Product Change Notification

PANEL CONTROLS

Model 3310 Epoxy Process

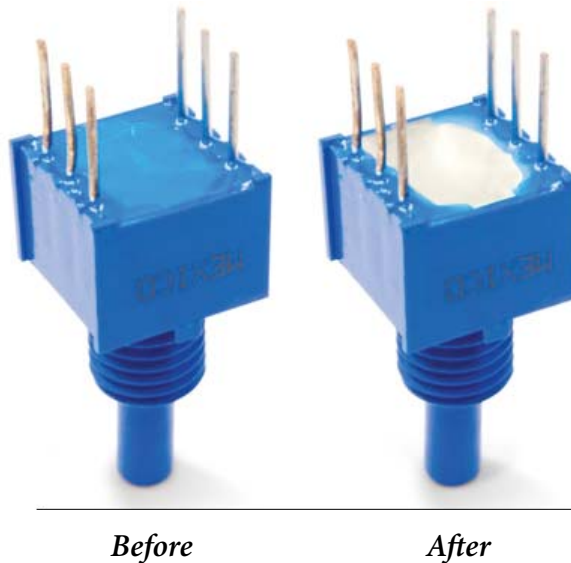
Bourns® Sensors & Controls Product Line is making a process change and a change in material to the [Model 3310](#), 9 mm Square Sealed Panel Control family. The changes involve converting from a two-part epoxy to a UV epoxy process. The primary advantage of the UV epoxy is the elimination of the antimony that is present in the two-part epoxy materials. The change also allows implementation of a cleaner process which eliminates the possibility of epoxy run-in associated with the two-part epoxy process.

This change will not affect fit or function. The modified product will meet our published performance specifications. These changes will be made on all standard catalog and customer-specific devices.

The material and process changes will be implemented for shipments beginning February 1, 2012.
